Corrigenda to the proposal for the 06 series of amendments to Regulation No. 83
(Emissions of M₁ and N₁ vehicles)

The text reproduced below was prepared by the representative of the European Community to align the requirements of Regulation No. 83 with those of the European Union Directives 715/2007/EC and 692/2008/EC (Euro 5 emissions level) on the basis of informal document WP.29-148-12, which was transmitted at the 148th session of the World Forum for Harmonization of Vehicle Regulations (WP.29). The document proposes amendments to the proposal for the 06 series of amendments to Regulations No. 83 as in document ECE/TRANS/WP.29/2009/57 (transposition of Euro 5/6) and the document ECE/TRANS/WP.29/2009/134. The modifications to the text of ECE/TRANS/WP.29/2009/57 and ECE/TRANS/WP.29/2009/134 are marked in bold characters or strikethrough. The amendments are based on the proposals of document No. WP.29-148-12 and the conclusions of the meeting held on Brussels with the participation of several interested Parties and Stakeholders. (EC, Germany, Finland, France, Hungary, the Netherlands and ACEA)

Annex 3,

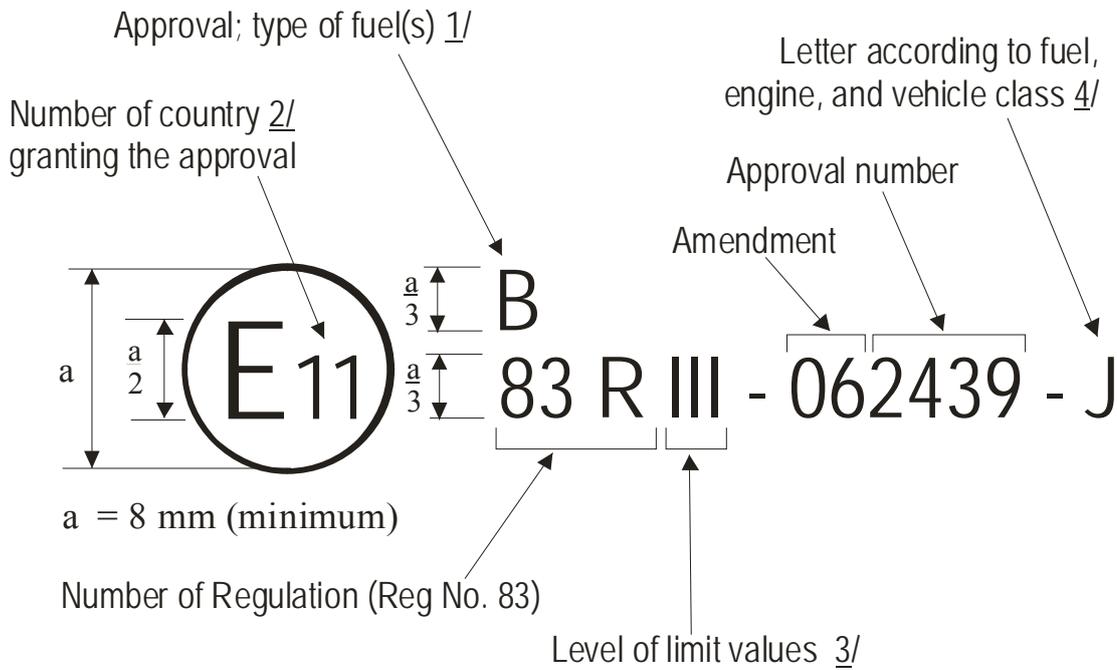
Replace the first figure of this annex, to read:

- 1/ B, C or D, according to type of fuel, paragraph 2.19. of this Regulation
- 2/ Number of country according to footnote in paragraph 4.4.1. of this Regulation
- 3/ III denotes limit values corresponding to Table 1, paragraph 5.3.1.4. of this Regulation
- 4/ According to Table 1 of this Annex
